From:	CHAIX Philippe <philippe.chaix@fr.thalesgroup.com>
Sent:	Thursday, October 09, 2014 8:27 AM
To:	Sam Buckwalter
Subject:	TR: Thales action about leg types preceding an IF leg

De : CHAIX Philippe
Envoyé : lundi 6 octobre 2014 13:02
À : sbuckwal@arinc.com
Objet : Thales action about leg types preceding an IF leg

Here is my proposal following the discussion about leg types before an IF leg.

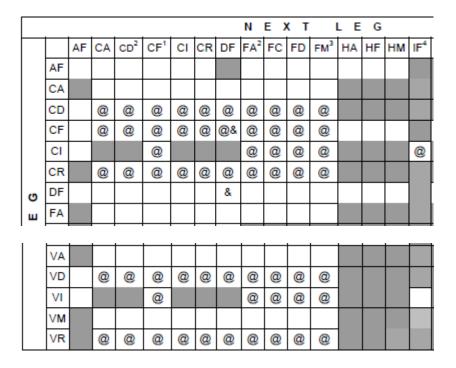
The illustration of rule 3.12 includes the following figure :

A coding example is provided when departing from runway 29, with a CA – VI – IF – TF sequence.

A departure from runway 11 (in another SID) could be coded VA – IF – TF, as the end of the VA leg can occur before or after the IF-TF segment.

There are many cases where a CF leg cannot be used because the corresponding fix is too far (more than 60 NM, and CF course generally coded with a resolution of 1°). I do not provide illustrations because of copyrights on the corresponding charts.

I propose to :
1) Go back to Arinc 424-20 leg sequencing table for the column "IF" (i.e. add CA, CD, CR, FA, VA, VD, VM, VR as possible previous leg)
2) Keep Arinc 424-21 draft Note 4 for the IF column, still applicable with this proposal : **"If the IF leg is not the beginning leg of the transition, such as an IF embedded leg, the next allowable next leg can only be TF. See Rule 3.12 in this attachment which describes the allowable use."**
3) Keep 3.12 of Arinc 424-21 draft 3 attachment 5 as it is, because the notion of interception has been removed.
